PROPOSED TECHNICAL SPECIFICATION CHANGE

SEQUOYAH NUCLEAR PLANT UNITS 1 AND 2

DOCKET NOS. 50-327 AND 50-328

(TVA-SQN-TS-91-08)

FIGURE 3.1-1

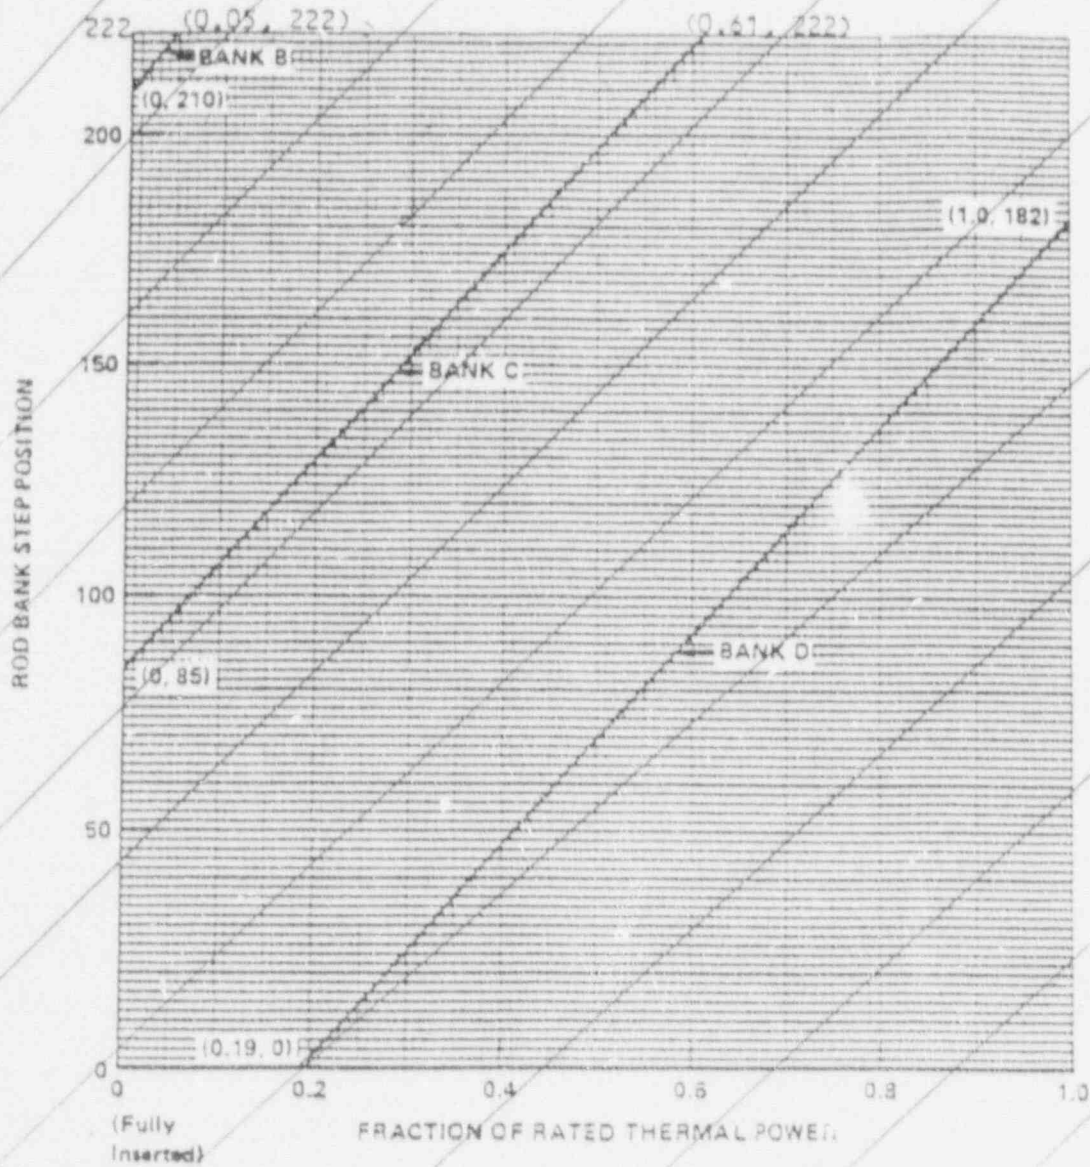
3.1.3.6 The control banks shall be limited in physical insertion as ~~shown in figure 3.1.1.1~~ SPECIFIED IN THE COLR. R45

- a. Restore the control banks to within the limits within two hours, or
- b. Reduce THERMAL POWER within two hours to less than or equal to that fraction of RATED THERMAL POWER which is allowed by the group position using the ~~above figure, or~~
 ← INSERTION LIMITS SPECIFIED IN THE COLR, OR R118
- c. Be in HOT STANDBY within 6 hours.

DELETE

DELETE

<u>PAGE*</u>	<u>TECHNICAL SPECIFICATION</u>	<u>CHANGE DESCRIPTION</u>
3/4 1-4	3.1.1.3 Moderator Temperature Coefficient (MTC)	Relocates MTC limits to the Core Operating Limit Report (COLR) and corrects references.
3/4 1-5	4.1.1.3 MTC Surveillance Requirements	Relocates MTC limits to the COLR and corrects references.
B3/4 1-2	3/4.1.1.3 Moderator Temperature Coefficient Bases	Change deletes specific MTC values.
3/4 1-14	3.1.3.1.c.2 Movable Control Assemblies-Group Height	Change replaces Figure 3.1-1 references with Specification 3.1.3.6.
3/4 1-20	3.1.3.5 Shutdown Rod Insertion Limit	Change clarifies that the fully withdrawn position for shut. rod banks is specified in the COLR.
3/4 1-21	3.1.3.6 Control Rod Insertion Limit	Change removes reference to Figure 3.1-1 and relocates to COLR.
3/4 1-22	Figure 3.1-1 Rod Bank Insertion Limits Versus Thermal Power Four Loop Operation	Relocates figure to COLR.

FIGURE 3.2-1

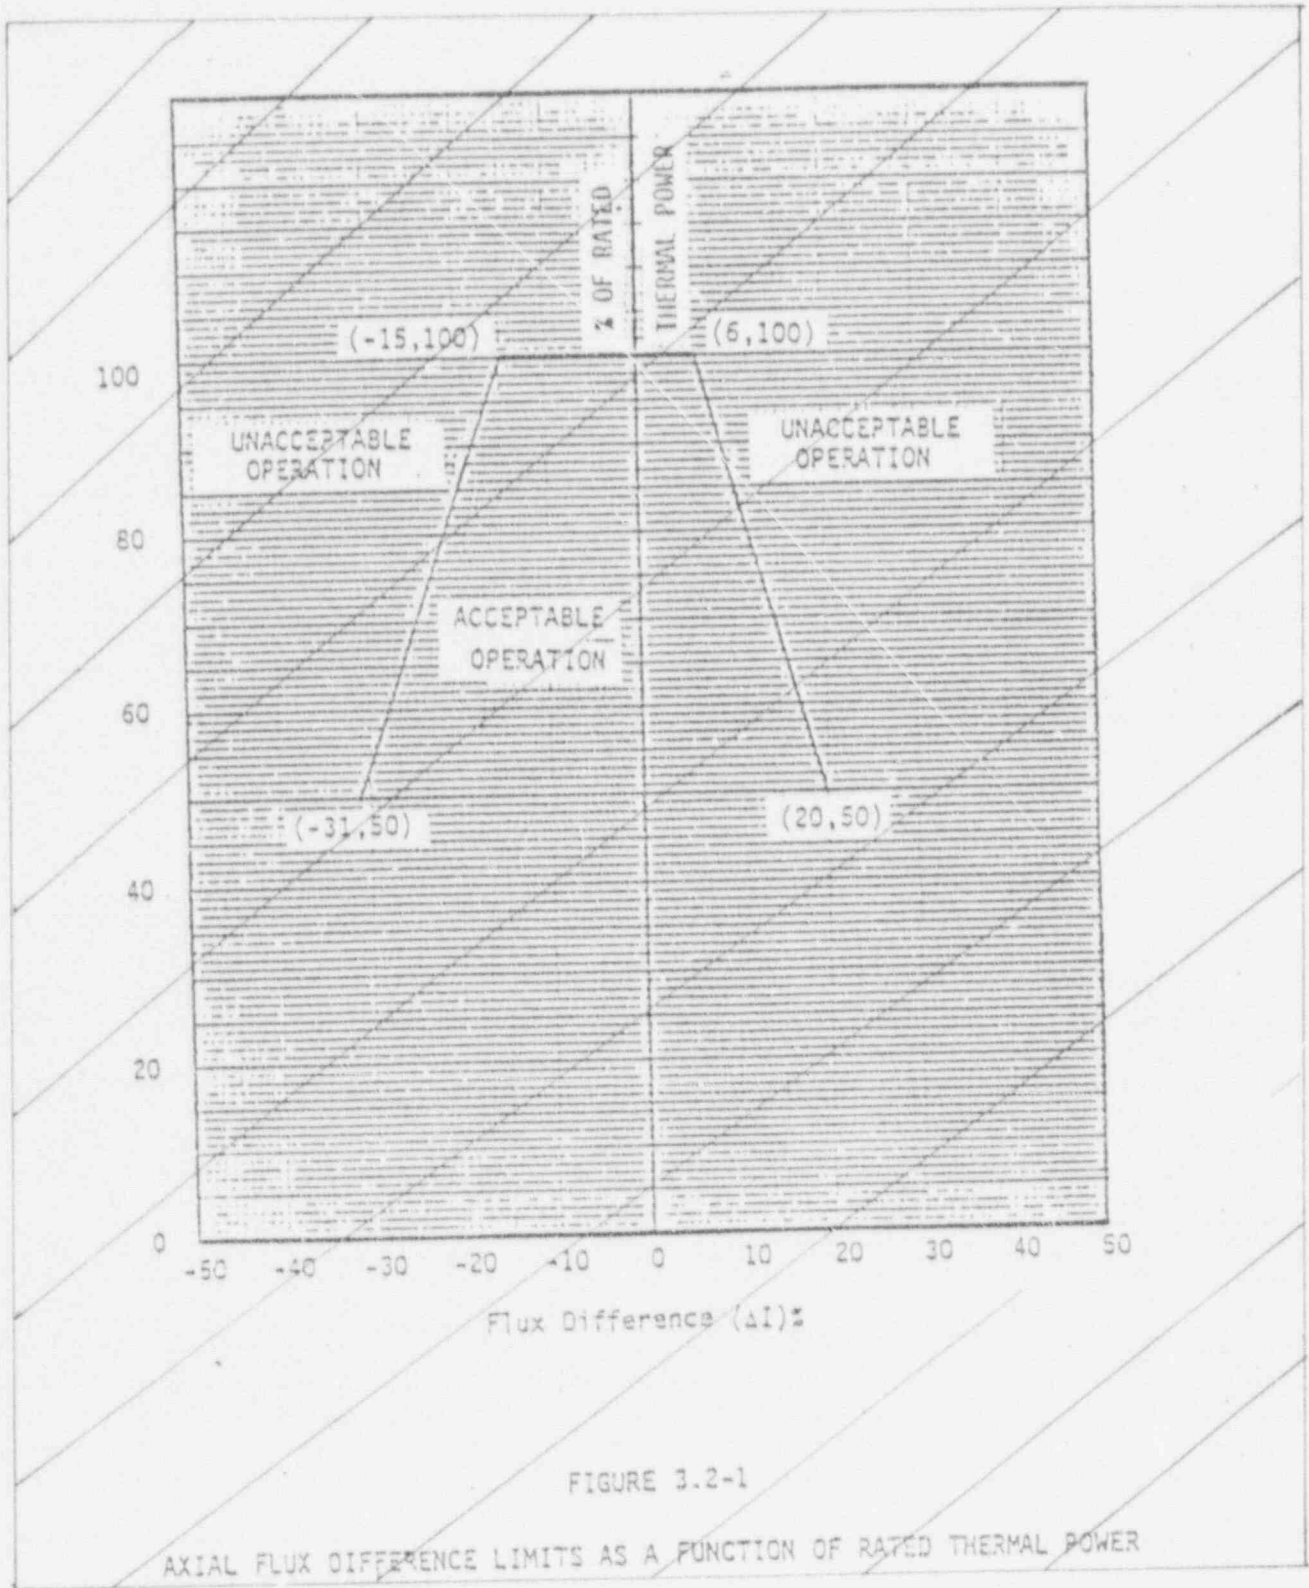
3.2.1 The indicated AXIAL FLUX DIFFERENCE (AFD) shall be maintained within the ~~allowed operational space defined by Figure 3.2-1.~~
LIMITS SPECIFIED IN THE COLR.

- a. With the indicated AXIAL FLUX DIFFERENCE outside of the ~~Figure 3.2-1~~ limits ~~x SPECIFIED IN THE COLR;~~
 1. Either restore the indicated AFD to within the ~~figure 3.2-1~~ limits within 15 minutes, or
 2. Reduce THERMAL POWER to less than 50% of RATED THERMAL POWER within 30 minutes and reduce the Power Range Neutron Flux-High Trip setpoints to less than or equal to 55 percent of RATED THERMAL POWER within the next 4 hours.
- b. THERMAL POWER shall not be increased above 50% of RATED THERMAL POWER unless the indicated AFD is within the ~~figure 3.2-1~~ limits ~~x SPECIFIED IN THE COLR.~~

3/4 1-23	Figure 3.1-1 Notation	Revised and relocated with figure to COLR.
3/4 2-1	3.2.1 Axial Flux Difference	Replaces references to Figure 3.2-1 that are moved to the COLR.
3/4 2-4	Figure 3.2-1 Axial Flux Difference Limits as a Function of Rated Thermal Power	Figure moved to the COLR.
B3/4 2-1	3/4.2.1 Axial Flux Difference Bases	The F_Q limit is removed and reference to the COLR added.
B3/4 2-2	3/4.2.2 and 3/4.2.3 Heat Flux and Nuclear Enthalpy Hot Channel Factors Bases	Relocates the numerical value of $F_{\Delta H}$ to the COLR.

Figure 3.2-2

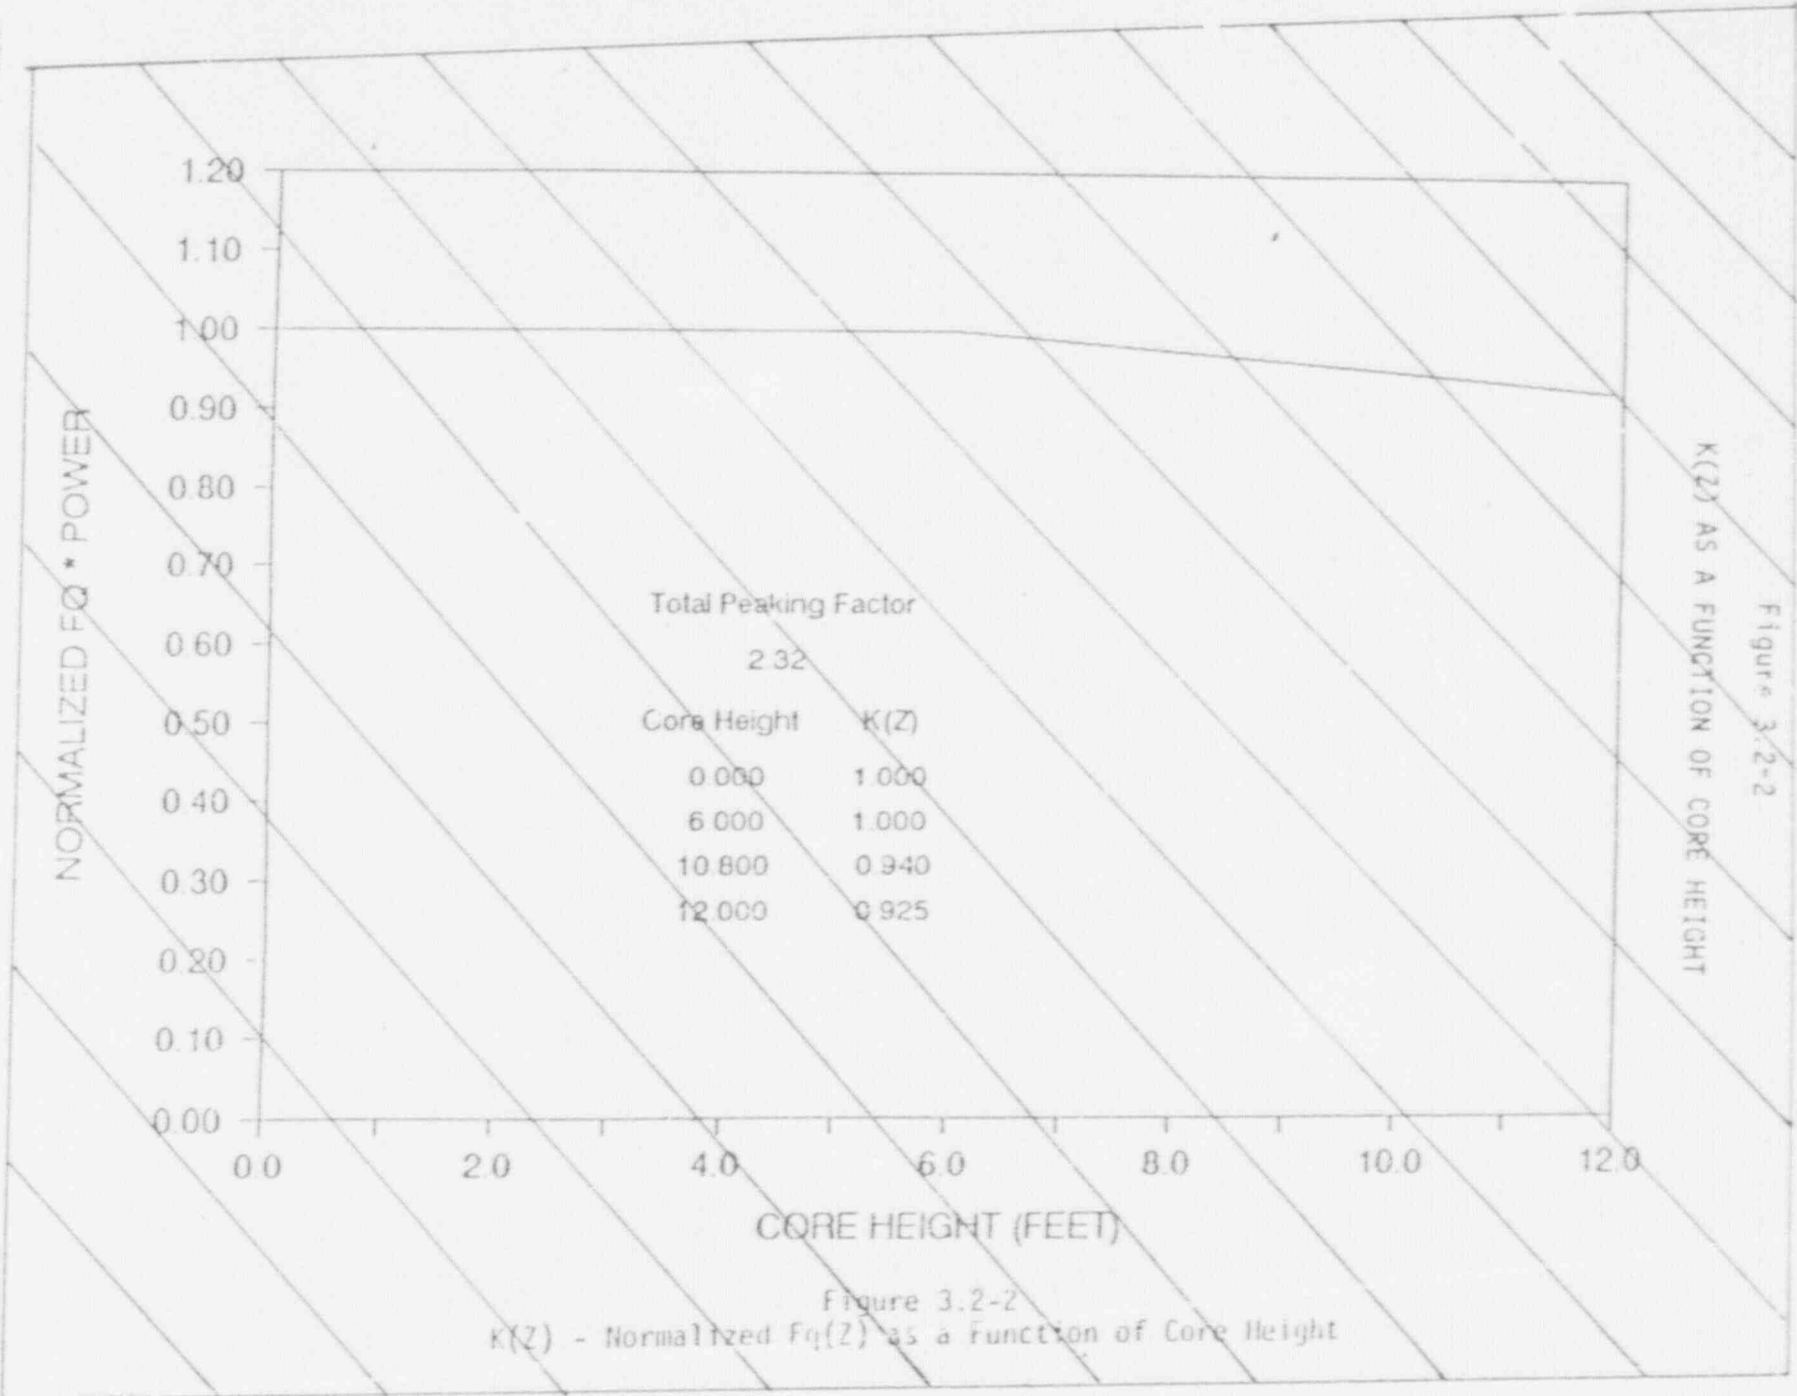
$K(Z)$ = THE NORMALIZED $F_Q(Z)$ AS A FUNCTION OF
and $K(Z)$ is the function obtained from Figure 3.2.2 for a given
~~core height location. CORE HEIGHT SPECIFIED IN THE COLR.~~

where $F_Q^M(z)$ is the measured $F_Q(z)$ increased by the allowances for manufacturing tolerances and measurement uncertainty, F_Q limit is the F_Q limit, $K(z)$ is given in Figure 3-2-2, P is the relative THERMAL POWER, and $W(z)$ is the cycle dependent function that accounts for power distribution transients encountered during normal operation. This function is given in the Peaking Factor Limit Report as per Specification 6.9.1.14. F_Q^{RTP} , $K(z)$, AND $W(z)$ ARE SPECIFIED IN THE COR AS PER SPECIFICATION 6.9.1.14.

<u>PAGE*</u>	<u>TECHNICAL SPECIFICATION</u>	<u>CHANGE DESCRIPTION</u>
3/4 2-5	3.2.2 Heat Flux Hot Channel Factor	Relocates the F_Q and $K(Z)$ to the COLR. The numerical F_Q limit is replaced with a function F_Q^{RTP} , that is to be specified in the COLR.
3/4 2-6&7	4.2.2.2 Heat Flux Hot Channel Factor Surveillance Requirements	Same as 3.2.2 above.
3/4 2-9	Figure 3.2-2 $K(Z)$ -Normalized $F_Q(Z)$ as a Function of Core Height	Figure moved to the COLR.
3/4 2-10	3.2.3 Nuclear Enthalpy Hot Channel Factor	Relocates the numerical value of $F_{\Delta H}^{RTP}$ and defines $PF_{\Delta H}$ in the COLR.
B3/4 2-4	3/4.2.2 and 3/4.2.3 Heat Flux and Nuclear Enthalpy Hot Channel Factor Bases	The Radial Peaking Factor Limits Report is replaced by the COLR.
6-21	6.9.1.14 Radial Peaking Factor Limit Report	Replace the Radial Peaking Factor Report with the COLR.

FIGURE 3.1-1

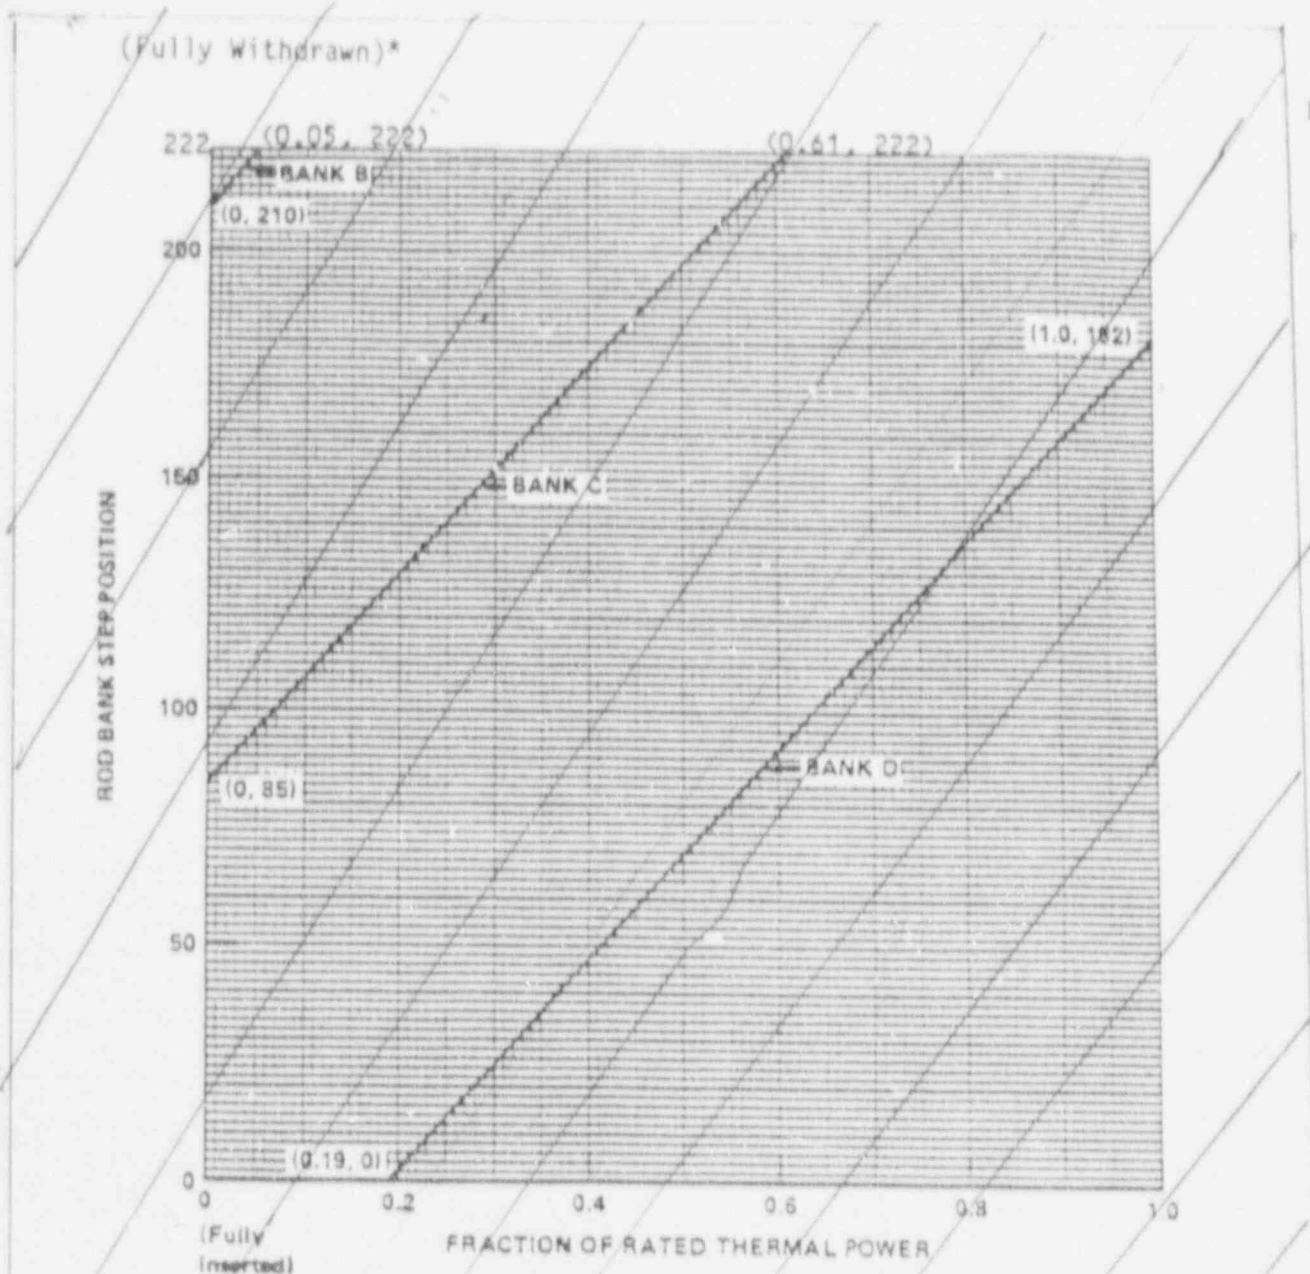
3.1.3.6 The control banks shall be limited in physical insertion as ~~shown in~~ R33
~~Figure 3.1-1, SPECIFIED IN THE COLOR.~~

DELETE

FIGURE 3.2-1

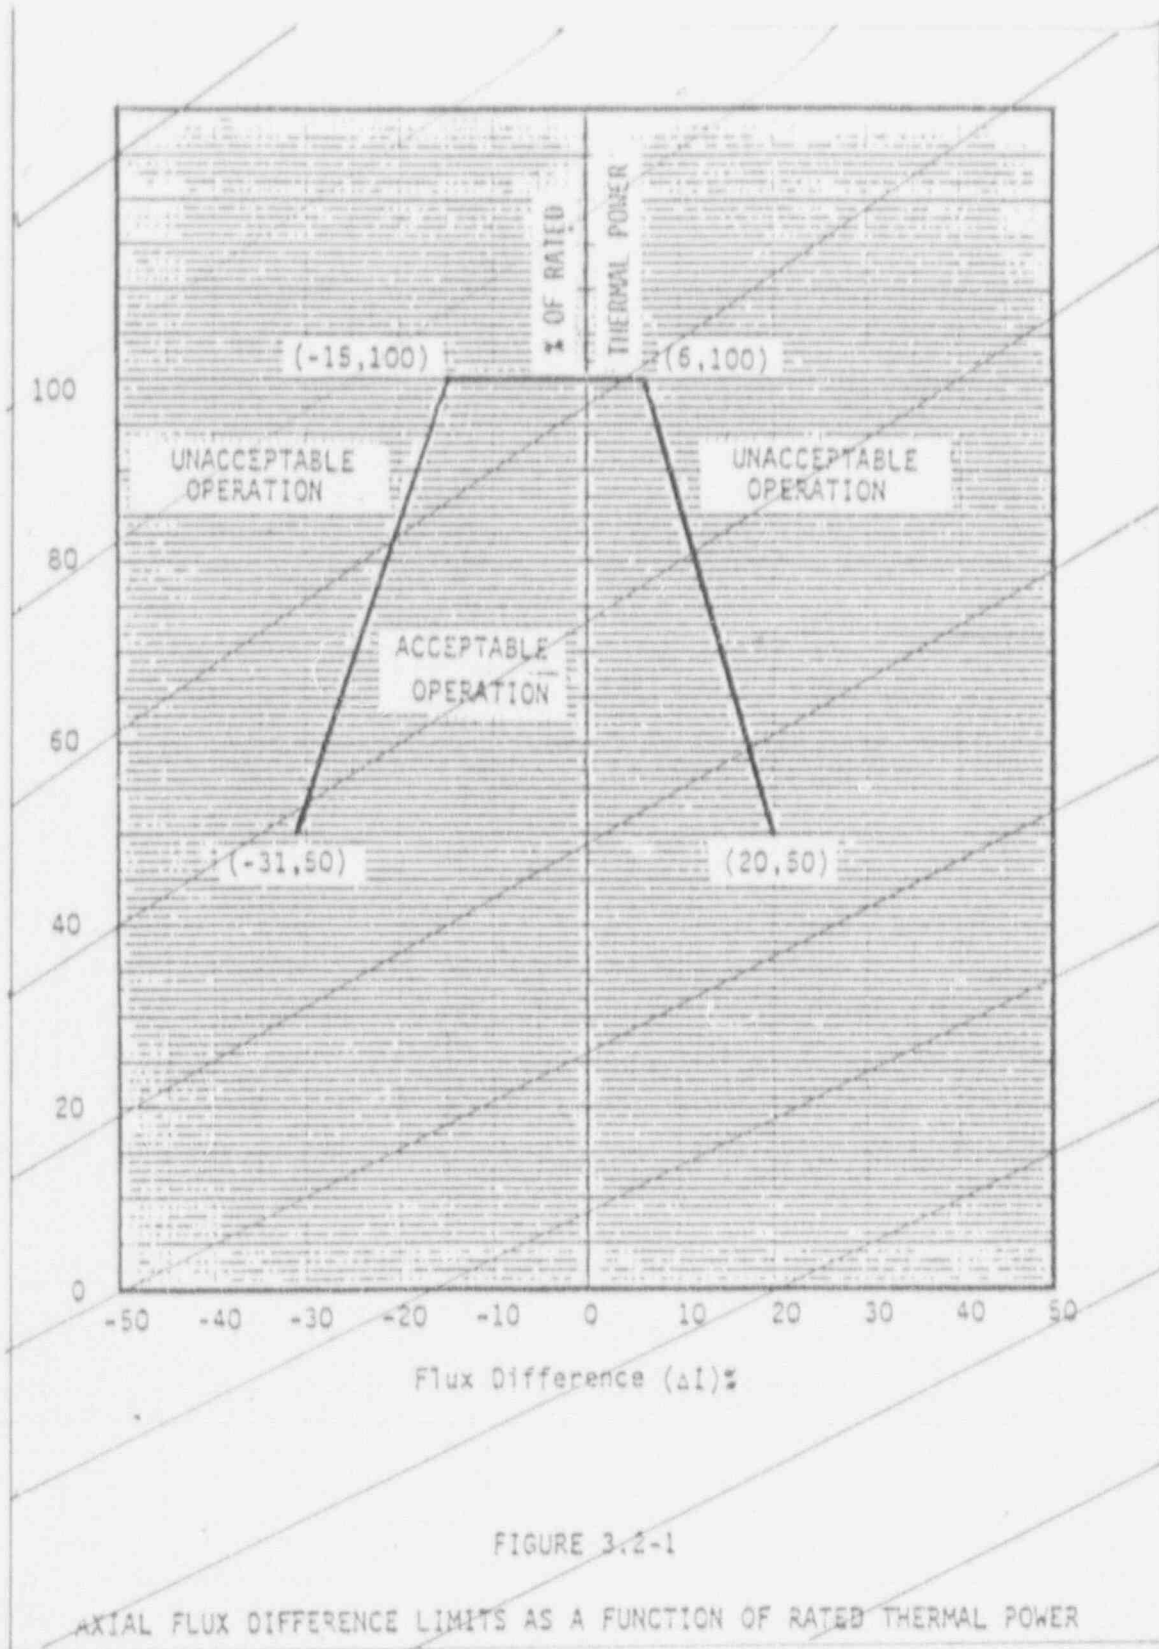
3.2.1 The indicated AXIAL FLUX DIFFERENCE (AFD) shall be maintained within the ~~allowed operational space defined by Figure 3.2-1.~~
LIMITS SPECIFIED IN THE COLR.

- a. With the indicated AXIAL FLUX DIFFERENCE outside of the ~~Figure 3.2-1~~ limits *SPECIFIED IN THE COLR*;
1. Either restore the indicated AFD to within the ~~Figure 3.2-1~~ limits within 15 minutes, or
 2. Reduce THERMAL POWER to less than 50% of RATED THERMAL POWER within 30 minutes and reduce the Power Range Neutron Flux-High Trip setpoints to less than or equal to 55 percent of RATED THERMAL POWER within the next 4 hours.
- b. THERMAL POWER shall not be increased above 50% of RATED THERMAL POWER unless the indicated AFD is within the ~~Figure 3.2-1~~ limits *SPECIFIED IN THE COLR.*

DELETE
